Our Ref: R/2020/14/A and R/2016/20/D
File No: 2021/530190
Your Ref: SSD-9978934 and SSD 7684 MOD 1

Request for advice - Cockle Bay Park Redevelopment - Modification to Stage 1 (SSD 4684 MOD 1) and Stage 2 (SSD-9978934)

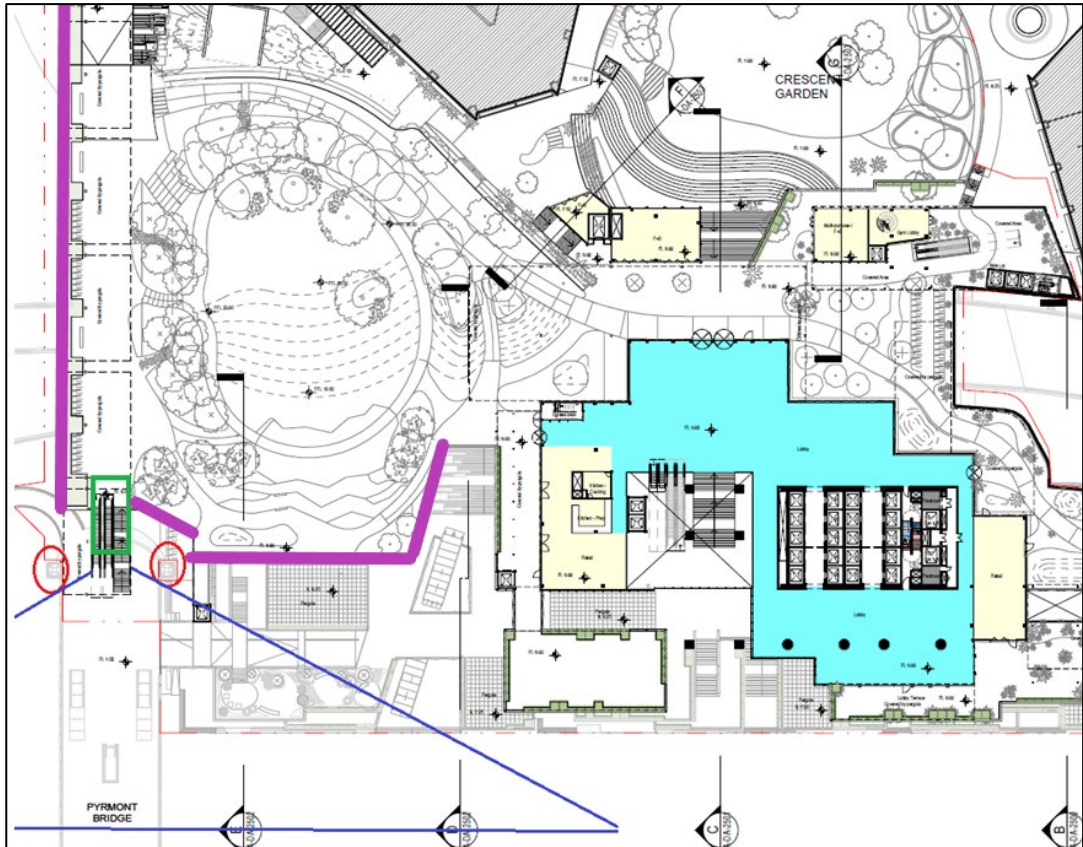
The land bridge to Market Street is superimposed on the eastern end of Pyrmont Bridge. The proposed pergola structure, along with the proposed elevated garden to the south, is perceived to intercept the Bridge. When viewed from the west, the Bridge appears to run under or into the proposed podium. As a result, the Bridge's role as a link of two districts is compromised. The historic relationship of the Bridge and Market Street, and the vista along the Bridge towards and with the CBD building clusters should be maintained and not obstructed by the proposed elevated linking bridge and garden at the northern end of the development site. The Bridge should read as an independent structure – this requires reconsideration with more openness and respect to the heritage bridge.

To reduce impacts to the Pyrmont Bridge, the City recommends that sight lines from the bridge towards the west and south-west be retained, be free from building elements or be no higher than 11.55 metres. To also improve the heritage curtilage of the development, it is recommended that the walled edge of the land bridge and the podium be softened. These vertical 'cliffs' can be replaced by landscaped terraces. The distance between the pylons and the northern podium at RL19.6 should also be increased to maintain an adequate visual curtilage for the two pylons. The proposed escalators, stairs and the cover canopies affect the sightlines between the two stone pylon and are intrusive to the Bridge. They should be shifted to the eastern side of the pylons. Refer to **Figure 1** below.

Consider how to retain the routine of the existing foot bridge connecting Pyrmont Bridge with Market Street as the northern edge of the land bridge and elevated open space at RL19.6.

Figure 2: Recommendations to improve curtilage from the promenade.
 Red line – recommended building setback
 Green line – retain existing footpath and landscaping within this area.

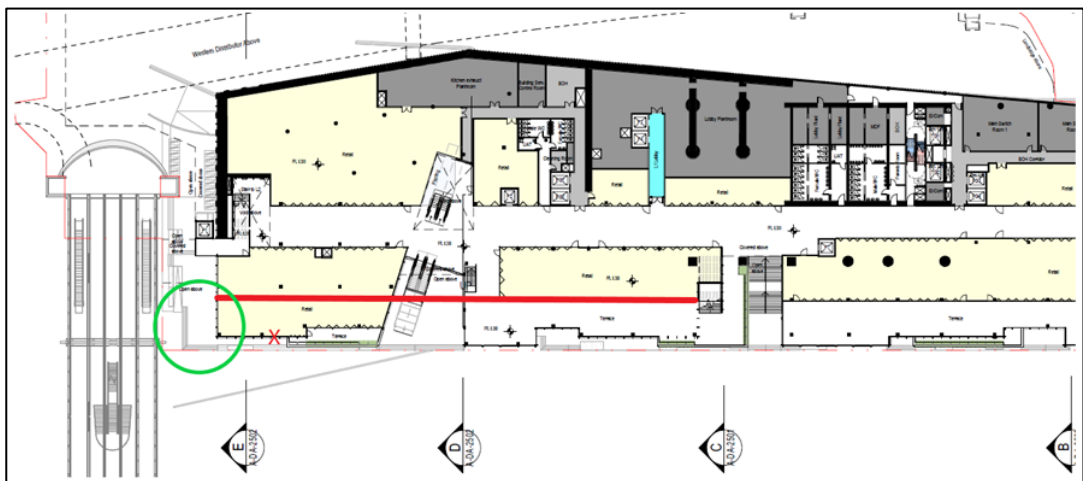
Similarly, the proposal should provide a curtilage to the Pyrmont Bridge at the promenade level. As proposed, the development removes the existing landscaped buffer and reduces the setback from the Pyrmont Bridge. The proximity of the proposed building and retail at the north-west corner of the podium impacts the visibility of Bridge, notably its truss and stone pylon.

Therefore, the City recommends that the north-west corner of the podium be redesigned so that its western edge allows the Bridge and its elements to be more legible. This can be achieved by aligning the western edge of the podium with the edge of retail tenancies or by providing a setback and separation to the Bridge that emulates the existing building. This would also retain the movement of pedestrians at this key point along the water promenade. Refer to **Figure 2** below.
